BRIEF DESCRIPTION OF REQUEST
 Site Plan Amendment for a previously approved with conditions by EPC at 10127 Coors Blvd NW (SI-2021-00985) to allow for commercial development on a parcel previously used as a drainage pond that has been partially reclaimed.

PROJECT NAME: Coors and 7 Bar Commercial Development (SI-2021-00985)

Project #2021-005687, SI-2021– 00985
Amendment to Site Plan

Re: 10127 Coors Boulevard NW (SI-2021-00985) Site Plan Amendment

1 Site Plan- Scale: 1" = 50'-0"

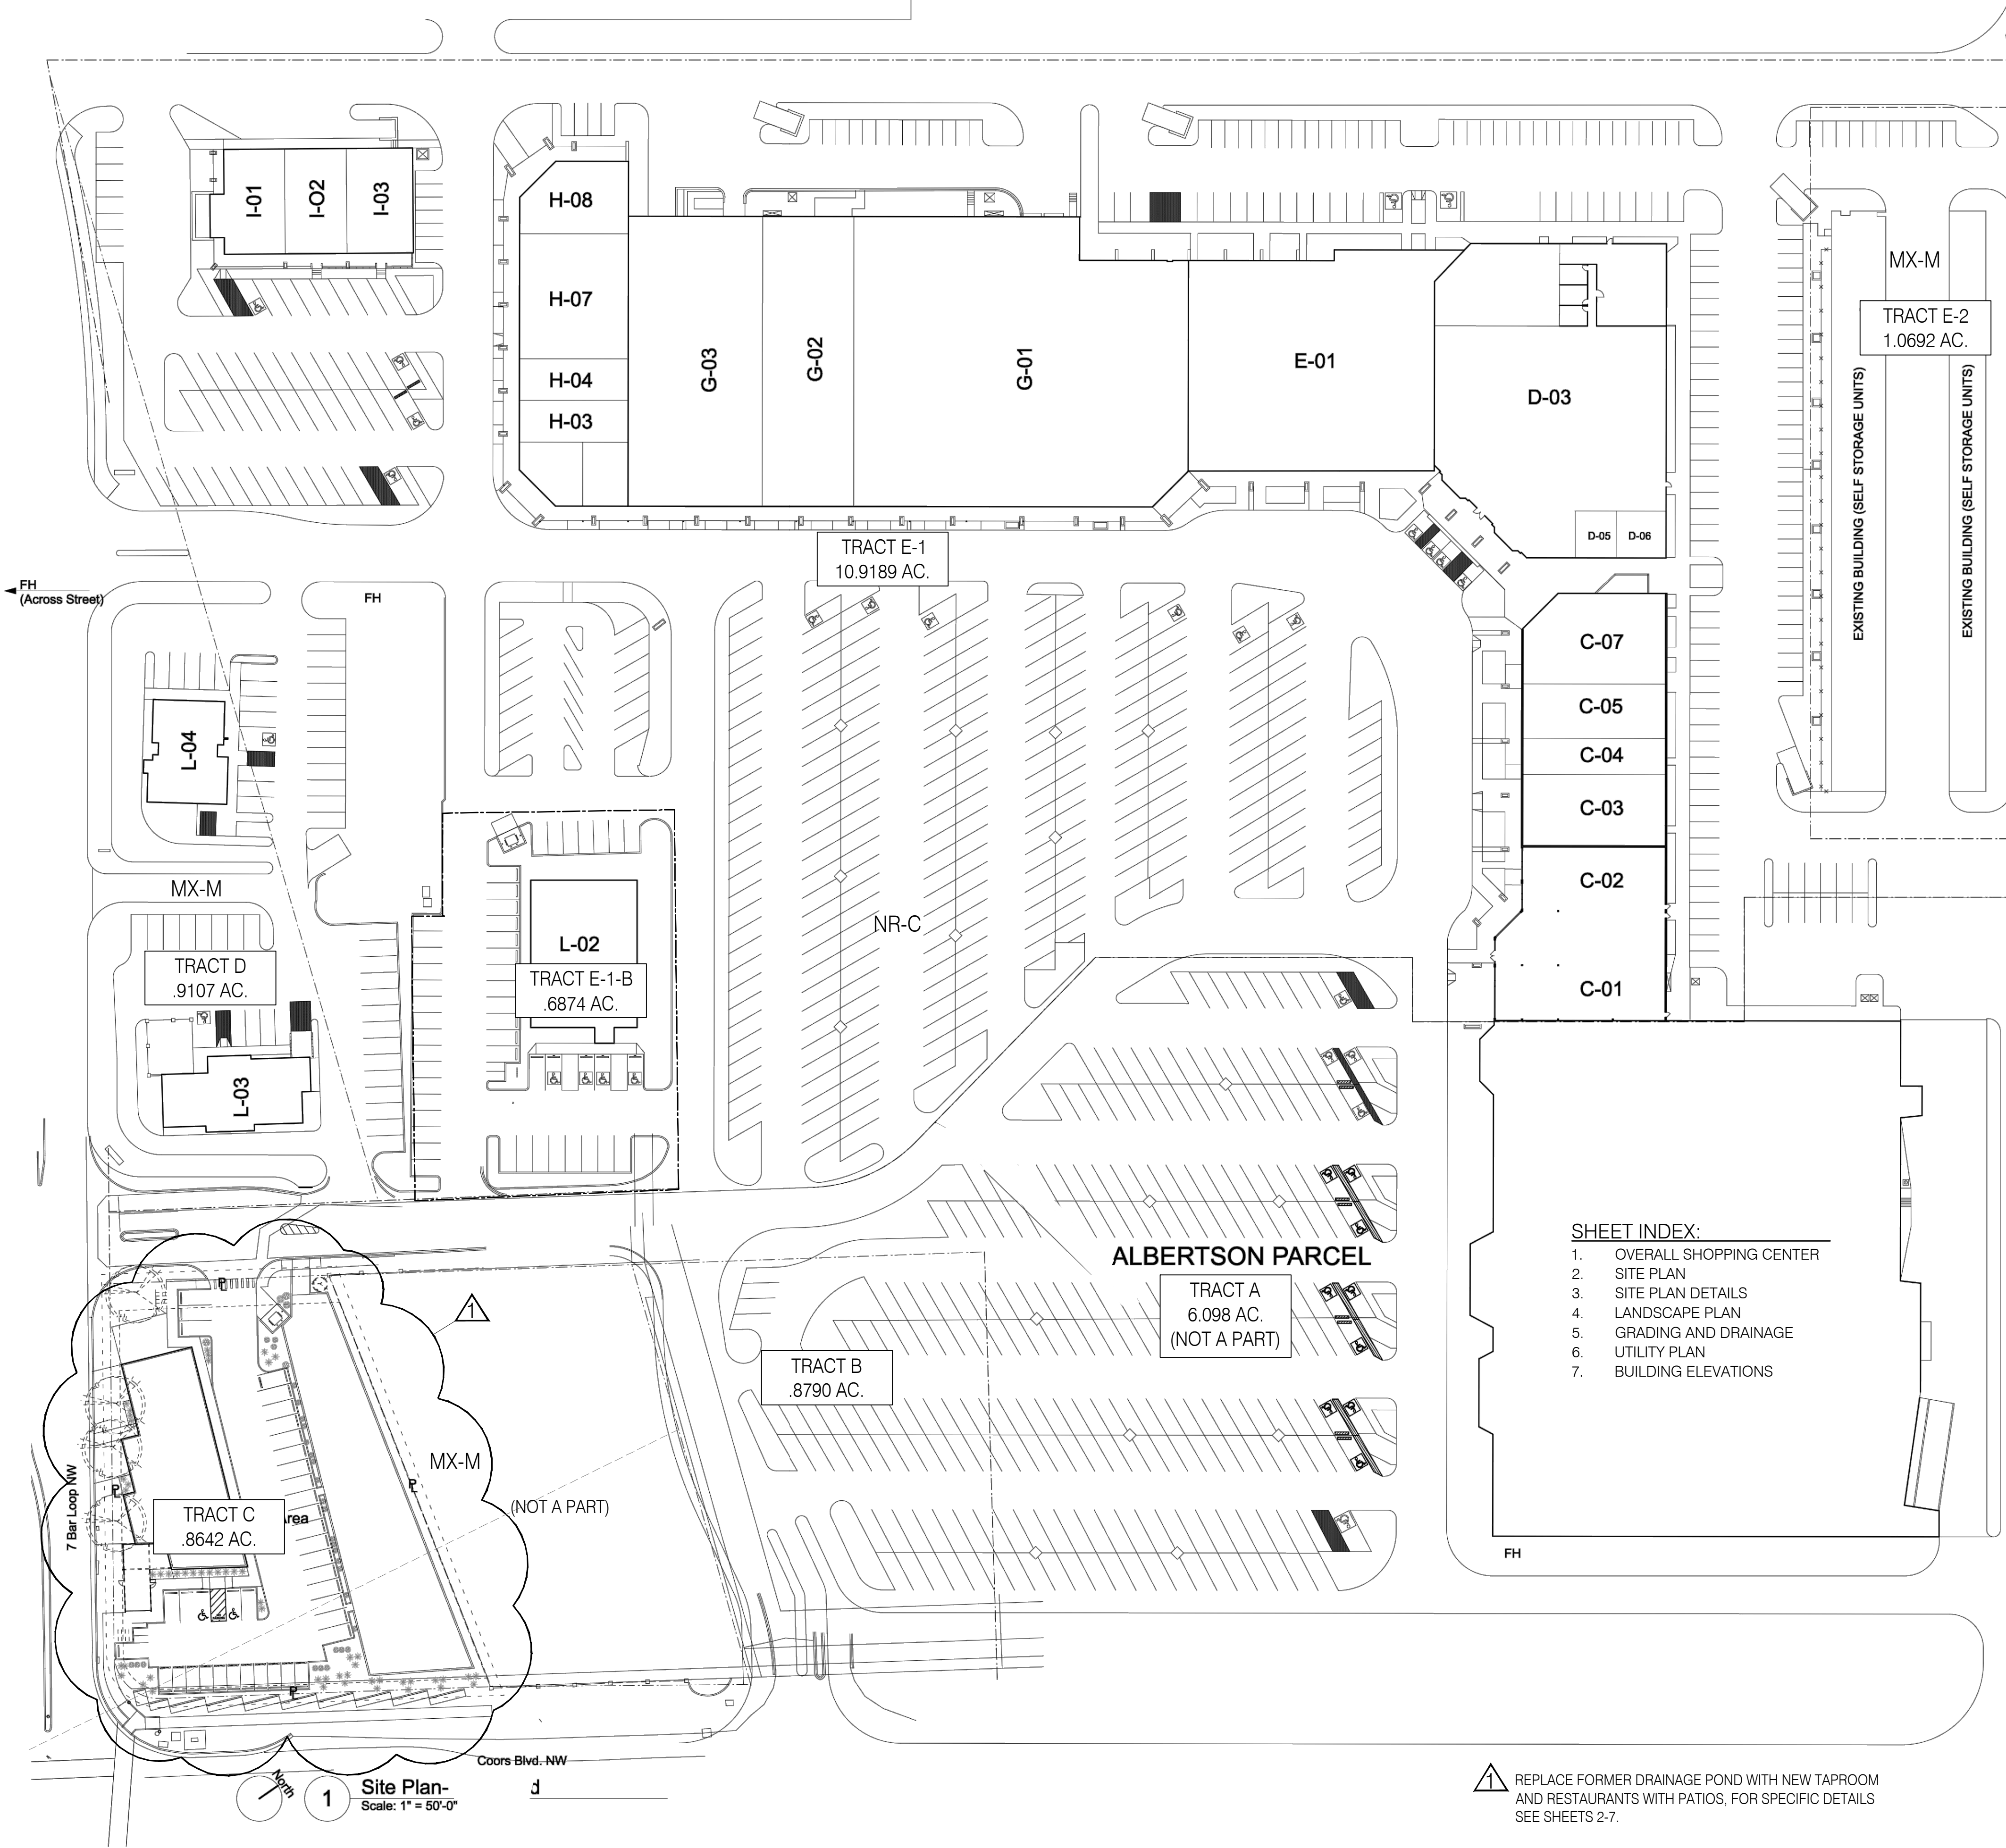
A. Parking calculations shall be shown clearly on-site plan, and shall comply with existing governing site plan.

6. Parking & Circulation:
- A. Parking calculations shall be shown clearly on site plan, and shall comply with existing governing site plan.
 - a. *Parking calculations have been provided on Sheet 1 of the Site Plan.*

3 Dumpster Enclosure Wall Detail
Scale: 3/8" = 1'-0"

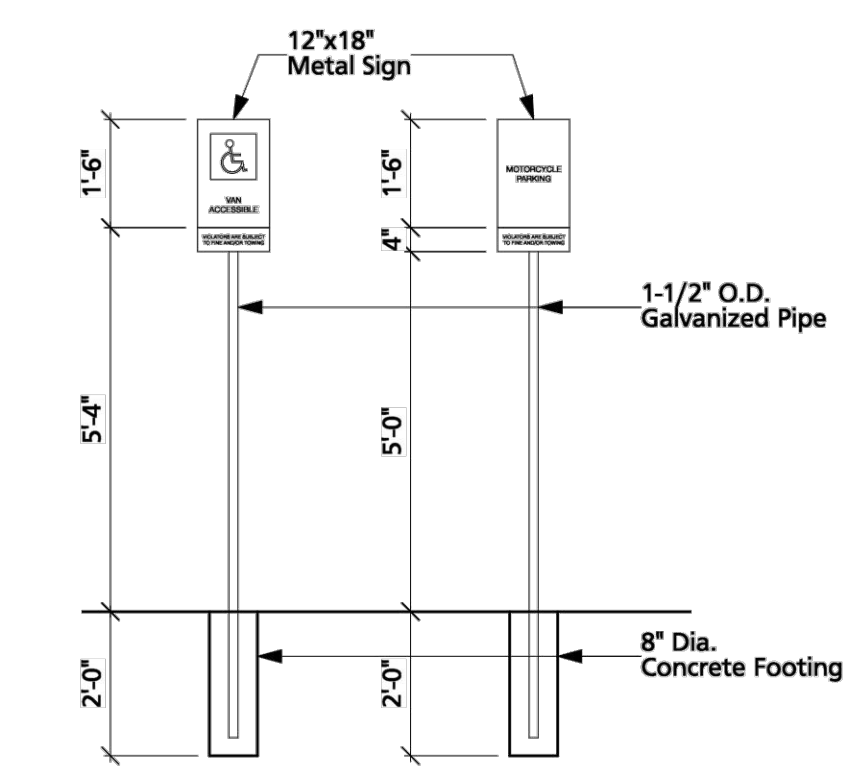
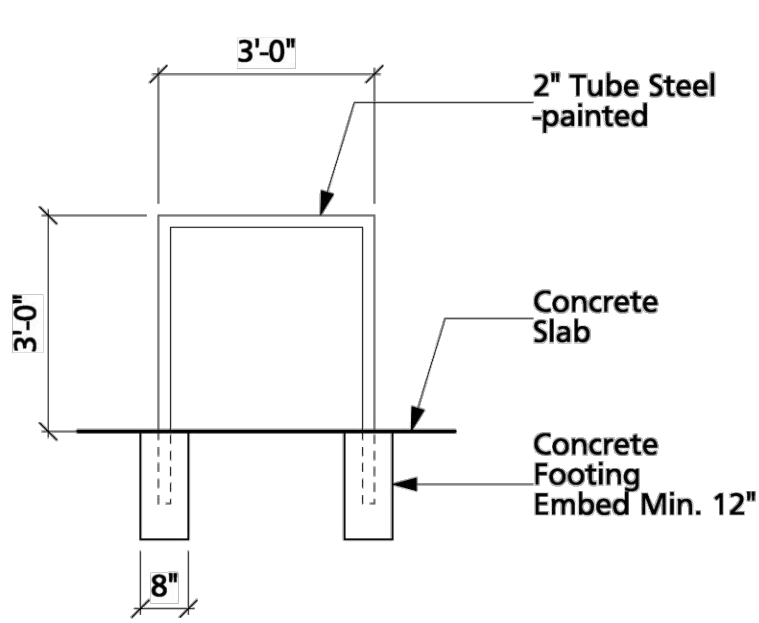
A. Specify color for dumpster enclosure detail.

- A. Specify color for dumpster enclosure detail.
 - a. *Color for dumpster enclosure will be one of the three stucco options found on Sheet 7 of the Site Plan.*

8 HC / Motorcycle Sign Detail
Scale: 3/8" = 1'-0"

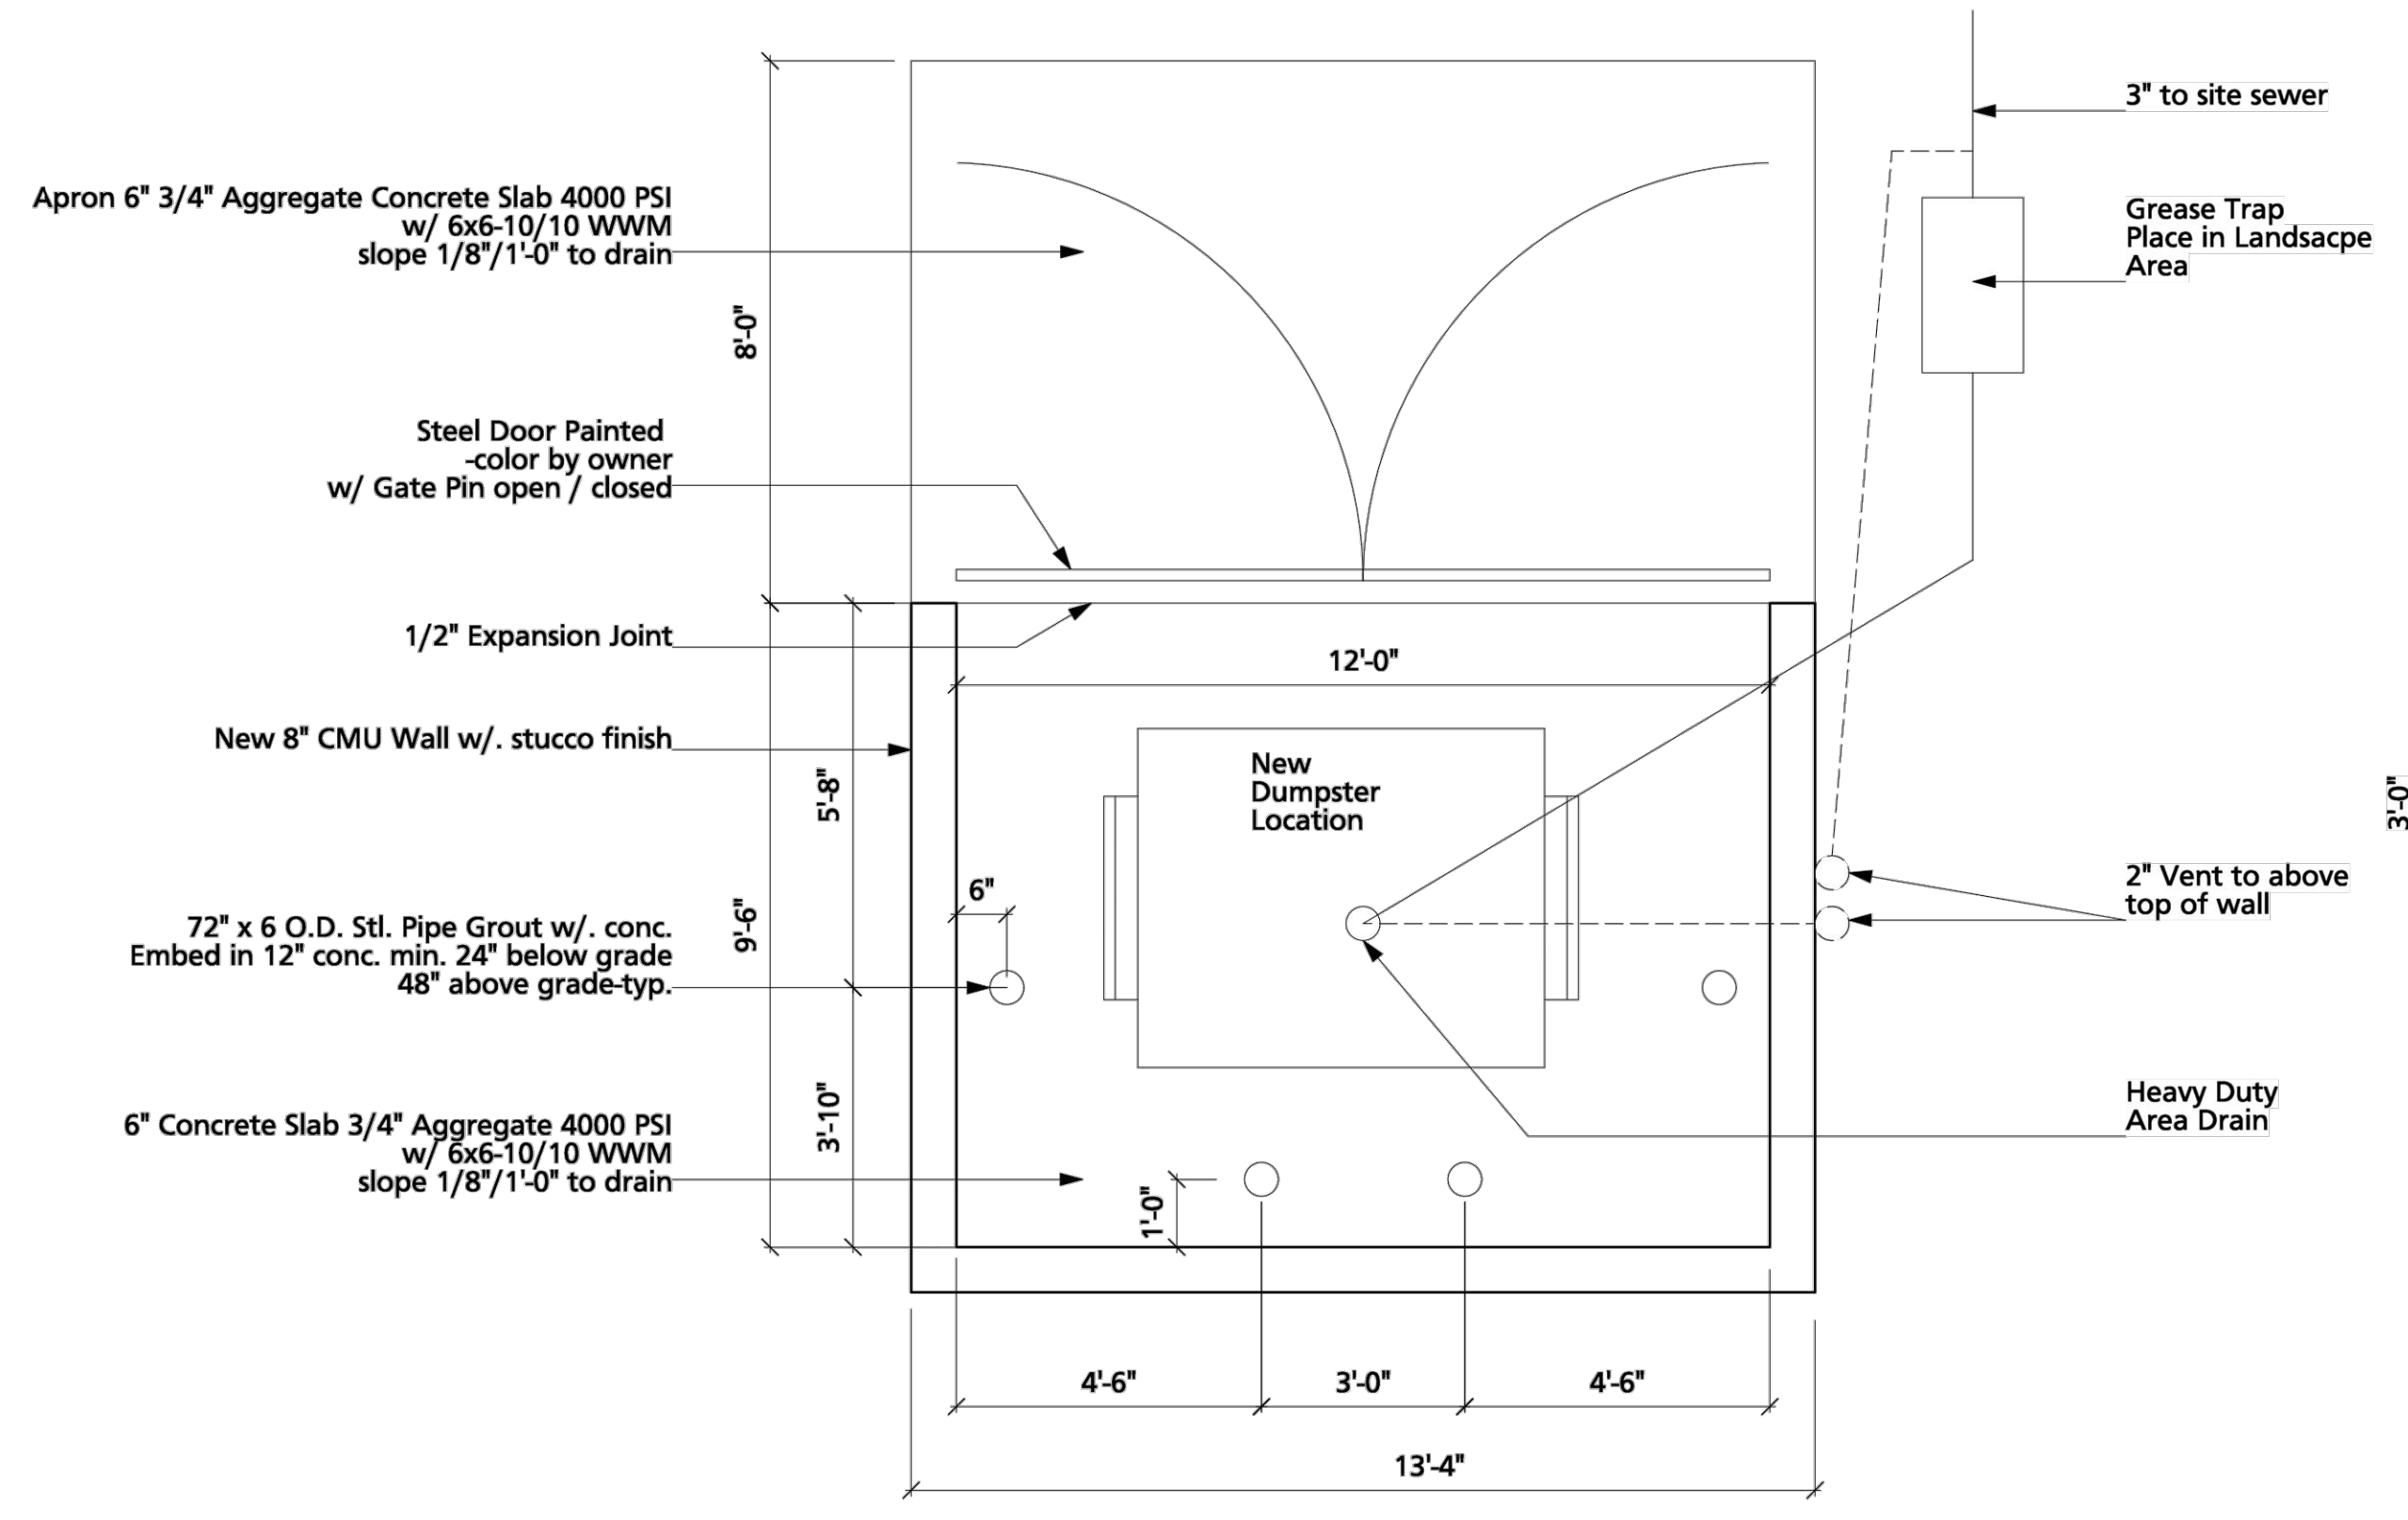
4. Site Plan General:
 - A. Setbacks standards for Coors Boulevard shall comply with IDO Section 14-16-3-4-(C)(3)(b)
 - B. A HC Sign detail shall be provided.

- C. A Motorcycle sign detail shall be provided.
 - D. A guard rail detail shall be provided.
 - E. A wall screening detail shall be provided.

- a. *Handicapped sign detail has been provided on Sheet 3 of the Site Plan.*
 - C. A motorcycle sign detail shall be provided.
 - a. *Motorcycle sign detail has been provided on Sheet 3 of the Site Plan.*
